802.1CB

Failure Mode Considerations

- Shows fault scenarios that may not be covered by the current 802.1CB Draft (1.0)
- Presents potential countermeasures to address or avoid these scenarios for discussion
- Relate to current industry standards on functional safety (e.g., ISO-26262 and IEC-61508)

Issue 1: Cut-Through and Corrupt Data

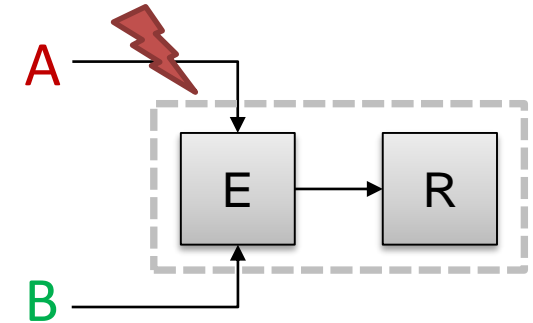
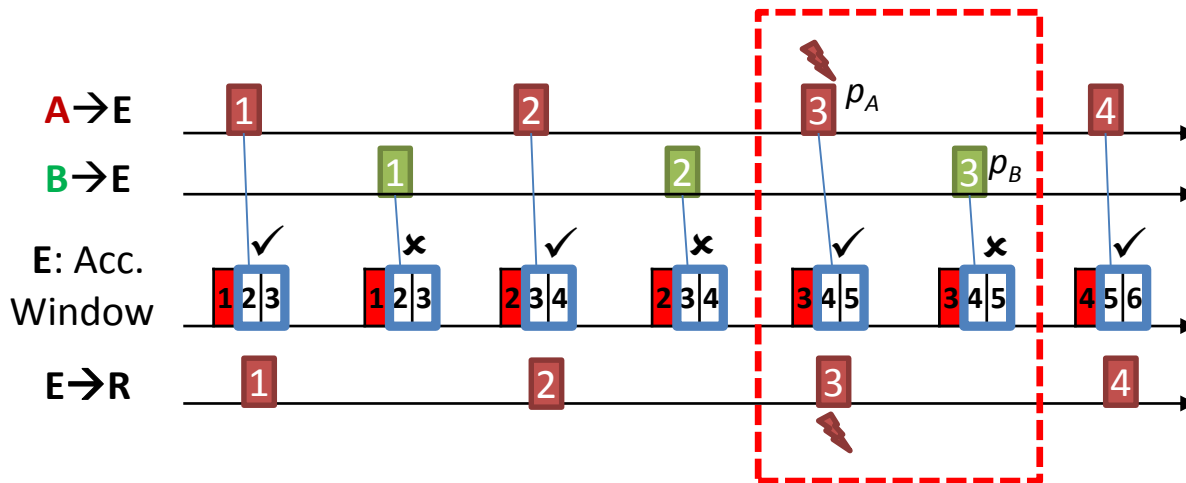
- *Message corruption* on path A causes data error in a packet p_A . At least E is performing cut-through forwarding.
- Consequence:
 - p_A is accepted by E, elimination of (fault free) duplicate p_B from channel B
- Present countermeasures:
 - **None:** FCS check in E is performed at the end of transmission

Issue 2: Cut-Through and Corrupt Sequence Numbers

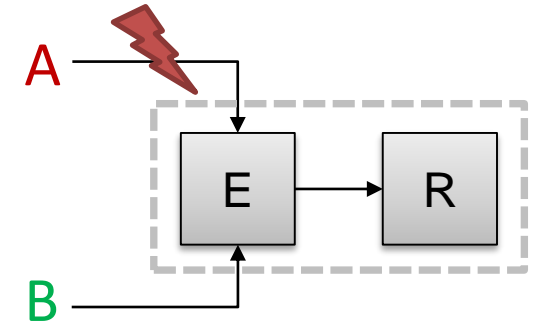
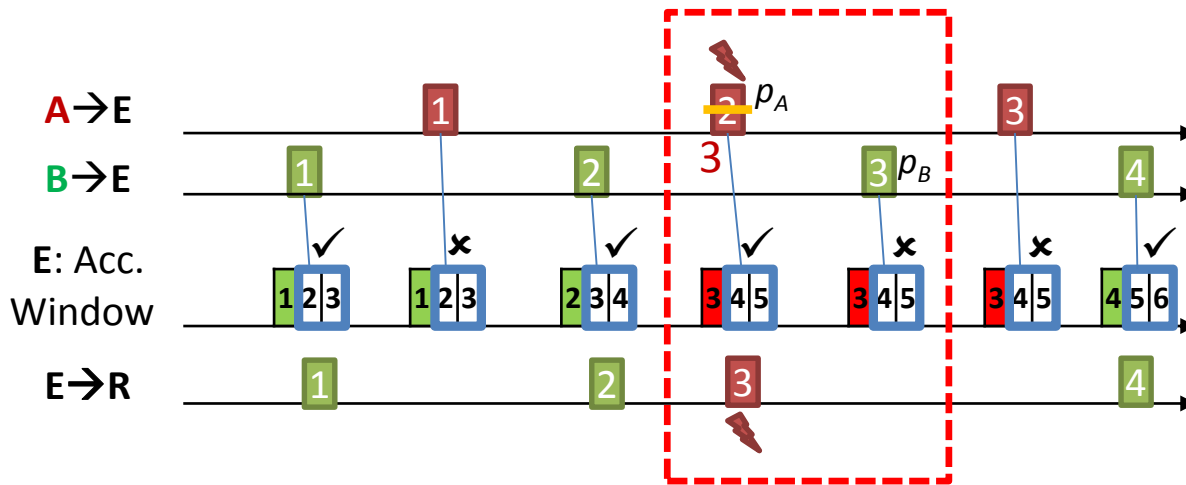
- *Message corruption* on path A causes erroneous sequence number in a packet p_A . At least E is performing cut-through forwarding.
- Consequence:
 - p_A is accepted by E, elimination of (fault free) duplicate p_B from channel B
 - In case of multiple broken sequence numbers, path A can (falsely) take over sequence number alignment in E
- Present countermeasures:
 - **None:** FCS check in E is performed at the end of transmission

Issues 1 & 2: Potential Countermeasures

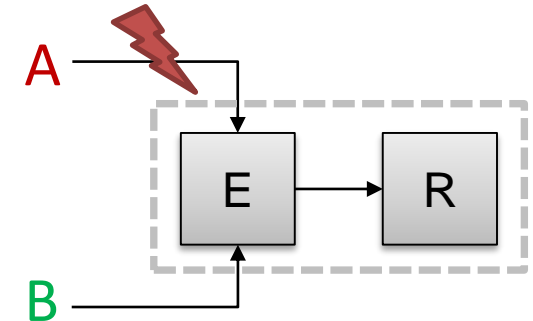
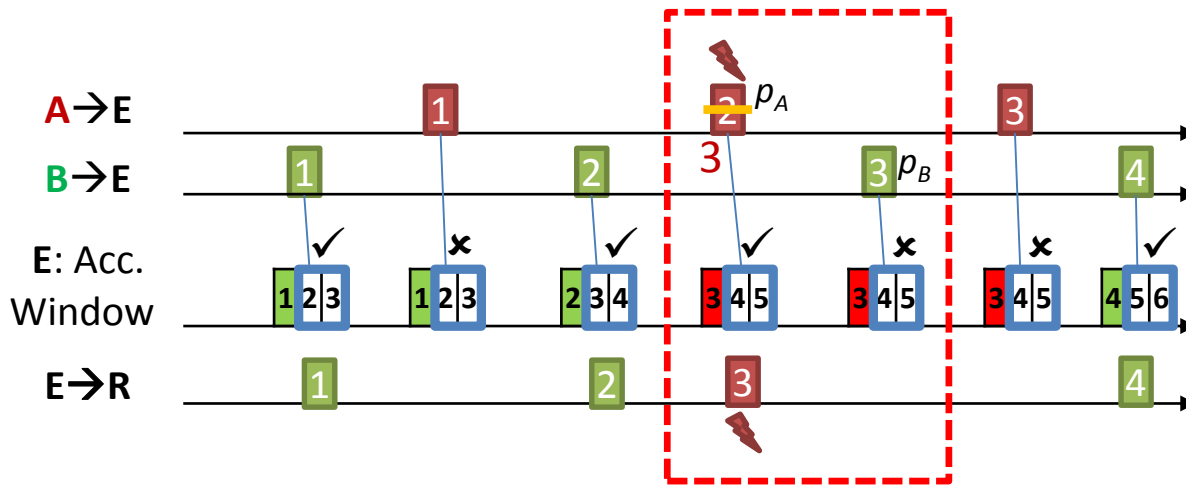
- *Don't do cut-through in E!*
Enforce finished FCS check before reaching 802.1CB FSMs at egress
- Describe the impact of cut-through and store & forward on reliability in 802.1CB
- Non-duplicating bridges shall treat the sequence number as data (i.e., not recompute it in any way).

Issues 1 & 2: Potential Countermeasures

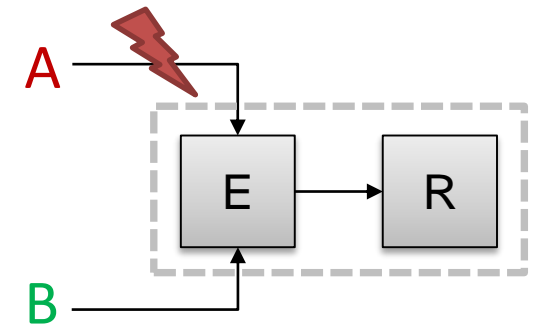
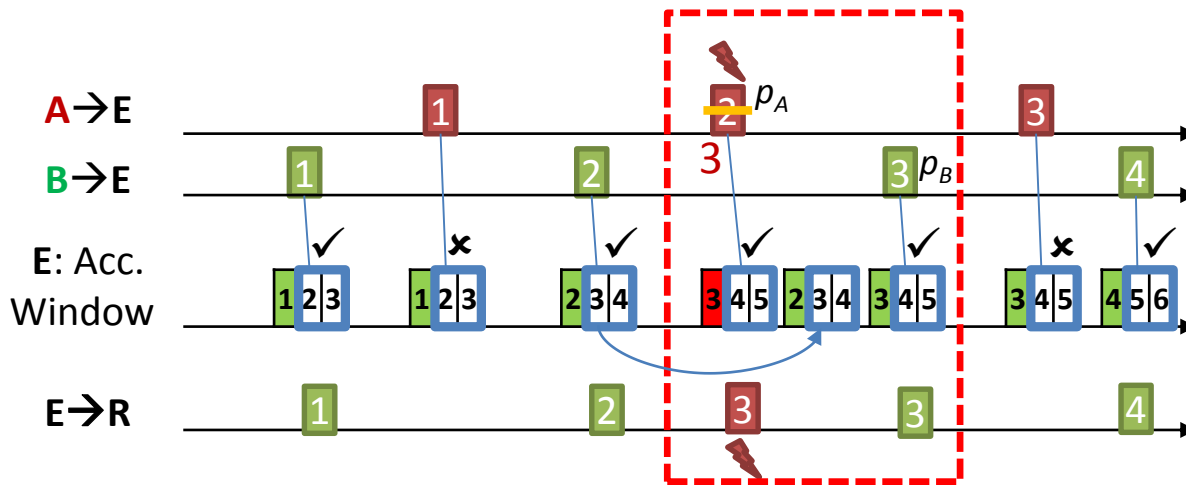
- Rollback of CB state in E if FCS check of p_A fails at packet end after FCS-Check
 - p_A is forwarded by E to R
 - CB state is reverted after FCS check of p_A
 - p_B is not eliminated but forwarded as first duplicate
- Negative implications:
 1. Increased complexity of bridge implementation
 2. Forwarding p_A plus p_B causes overload at the output of E
 - If R is a bridge and implements policing, it may diagnose E as faulty (false-positive)
 - E itself cannot diagnose path A as faulty by policing: The overload is only visible by channels A&B in combination

→ **Seems to be a bad idea. Propose to stick with the specification option (previous slide).**

Issue 4: (Any) Message repetition by bridges

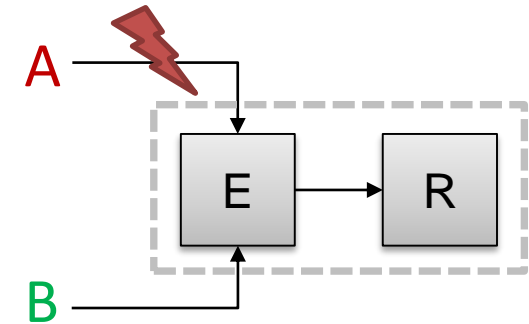
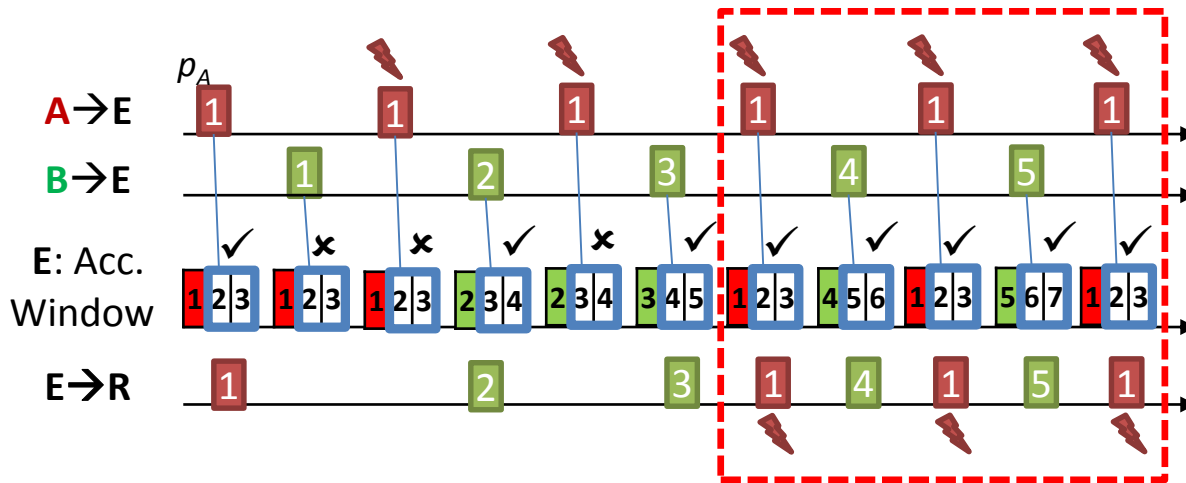
- *Message repetition* on path A causes repeated transmission of a packet p_A .
- Consequence:
 - Alternating alignment of the sequence history window to the sequence number of path A and path B (reset at “nearly” every sequence number), i.e.

$$\dots \rightarrow p_A \rightarrow p_{B,1} \rightarrow p_A \rightarrow p_{B,2} \rightarrow p_A \rightarrow p_{B,3} \rightarrow \dots$$
 - „Nearly“ duplicate load sent by E, may cause false positive 802.1Qci diagnosis of E by R. **R may block E entirely.**
- Present countermeasures:
 - **None**

Issues 4&5: Potential Countermeasures

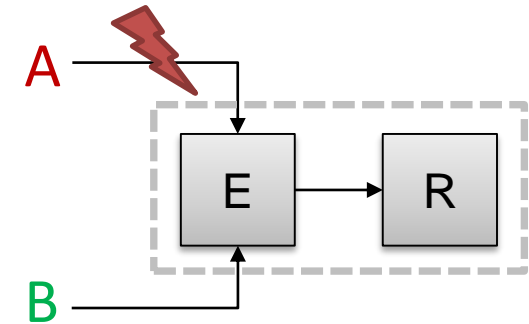
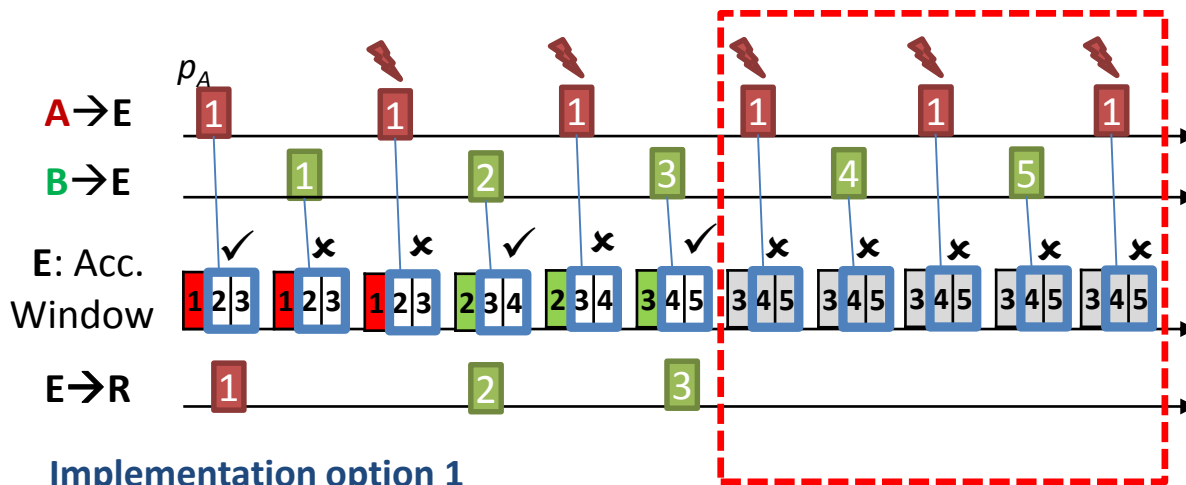
- Optionally disable recovery sequence number reset
- Once *any* sequence number out of the recovery history length is observed, assure that E no longer forwards the stream to R
- Permanently drops all packets of the stream from *both*, path A and B
- Either implemented in 802.1CB, or 802.1CB triggers 802.1Qci

1. Prevents the overload sent to R, i.e. avoids false positive diagnosis by R or congestion, but ..

2. Does not improve the reliability of the affected stream itself, since path B packets will also be dropped

→ **May be sufficient for fail-silent applications**

Issues 4&5: Potential Countermeasures

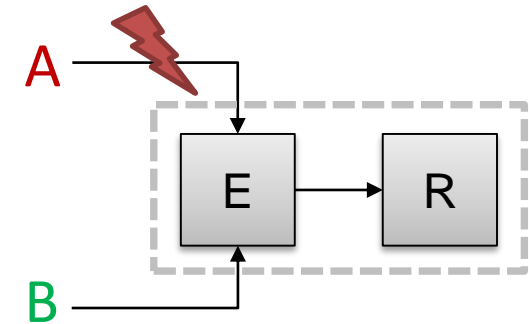
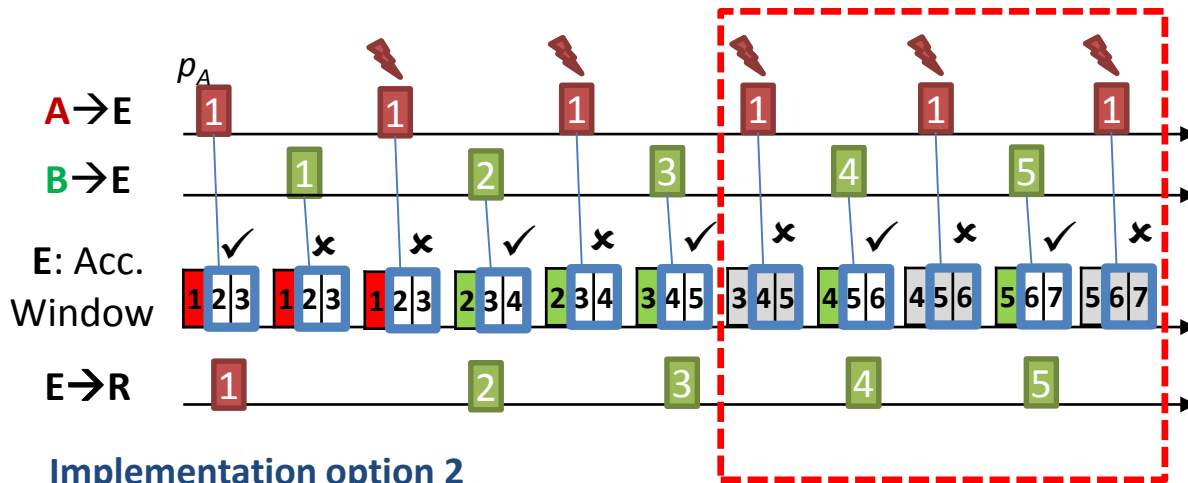
- Store recovery sequence number for each path of a stream independently, e.g. 2 offsets for path A and B
- Attention(!):
 - Requires more state, i.e. multiple recovery sequence numbers per stream
 - Sequence history window itself remains as it is (one per stream)

1. Prevents the overload sent to R and ...

2. Improves the reliability of the affected stream itself (the fault-free path will get through)

→ Open Topic: Masked path (A) invisible to listeners, i.e. even fail silent applications can't switch off

Issue 6: Possible Countermeasures

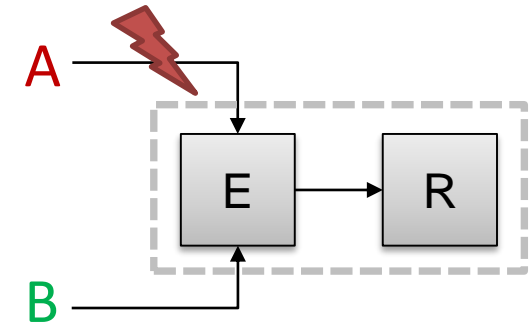
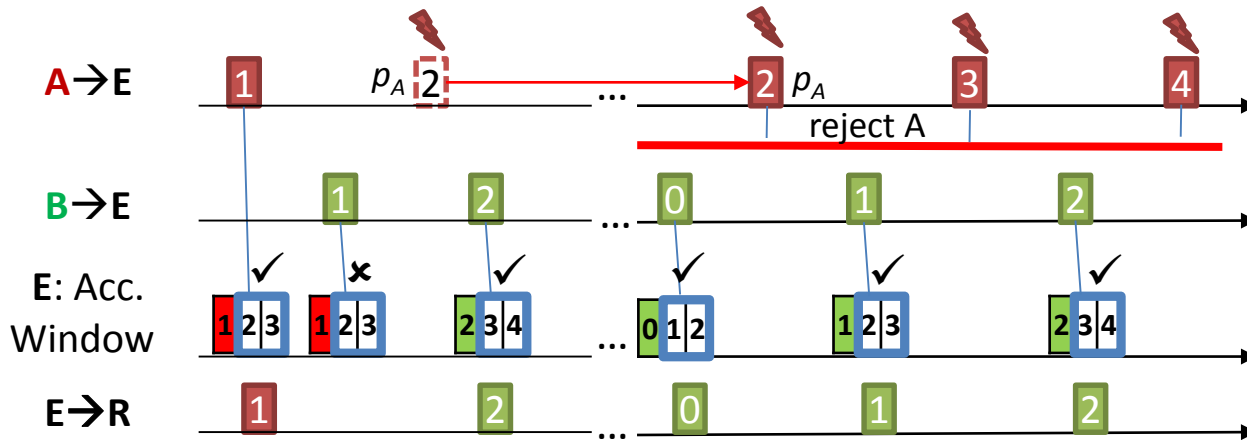
- This failure is not visible to listeners:
 - No gaps greater than recovery history length visible in the received packet stream
 - This issue is better handled by bridges...
- Implement a relative timeout measured in sequence numbers (i.e. a counter based timeout) between both paths:
 - Once one path alone has progressed the sequence number beyond the recovery history length, discard all packets from the other path
 - Could be done by notifying 802.1Qcj functions once this relative timeout is exceeded
 - Seems feasible, but **requires discussion**
